RENESAS TECHNICAL UPDATE

Product Category	MPU/MCU		Document No.	TN-RX*-A184A/E	Rev.	1.00
Title	Corrections to Descriptions for the P/E Suspend Command of Flash Memory in RX610 Group		Information Category	Technical Notification		
Applicable Product	RX610 Group	Lot No.	Reference Document	RX610 Group User's Manual: Hardware Rev.1.20 (R01UH0032EJ0120)

This document describes corrections to the descriptions for the SUSRDY bit and the flow chart of the P/E suspend command in the "ROM (Flash Memory for Code Storage)" section of RX610 Group User's Manual: Hardware.

Figure 26.19 Procedure for Programming/Erasure Suspension

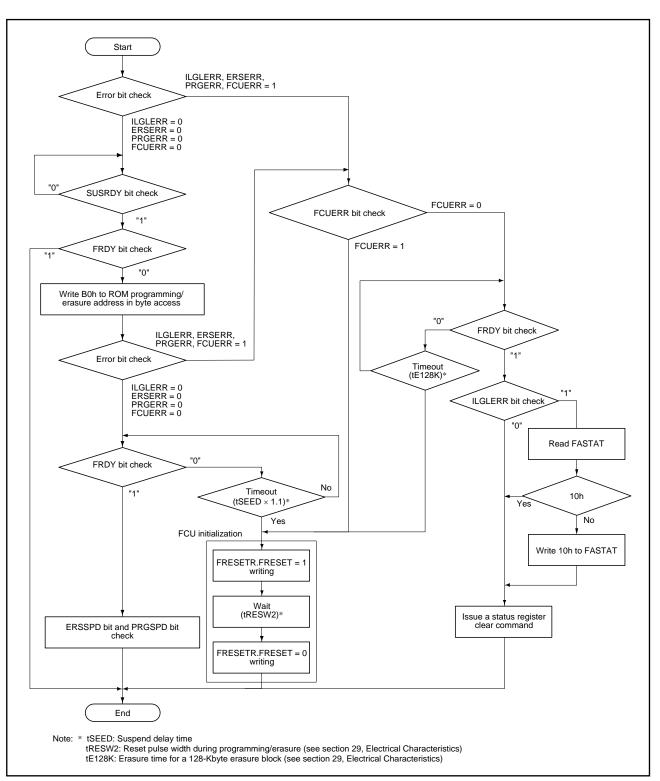
• Page 864 of 1003

In Figure 26.19, Procedure for Programming/Erasure Suspension, a processing flow never escapes from the loop for a checking procedure if the programming/erasure processing completed before checking the SUSRDY bit.

Therefore, a timeout processing and a breaking processing when the FRDY bit is 1 are to be added.

After correction Start ILGLERR, ERSERR, PRGERR, FCUERR = 1 Error bit check ILGLERR = 0ERSERR = 0PRGERR = 0 FCUERR = 0 "0" SUSRDY bit check "1" FRDY bit check "1" FRDY bit check No Timeout (tE128K) "0" Yes Write B0h to ROM programming/ erasure address in byte access FCUERR = 1 FCUERR bit check ILGLERR, ERSERR, PRGERR, FCUERR = 1 FCUERR = 0 Error bit check "0 ILGLERR = 0 FRDY bit check ERSERR = 0 PRGERR = 0 "1" Timeout FCUERR = 0 (tE128K)* "0" ILGLERR bit check FRDY bit check "0" "1" No Timeout (tSEED × 1.1) Read FASTAT Yes FCU initialization 10h FRESETR.FRESET = 1 Yes writing No Write 10h to FASTAT Wait (tRESW2)3 ERSSPD bit and PRGSPD bit FRESETR.FRESET = 0Issue a status register check
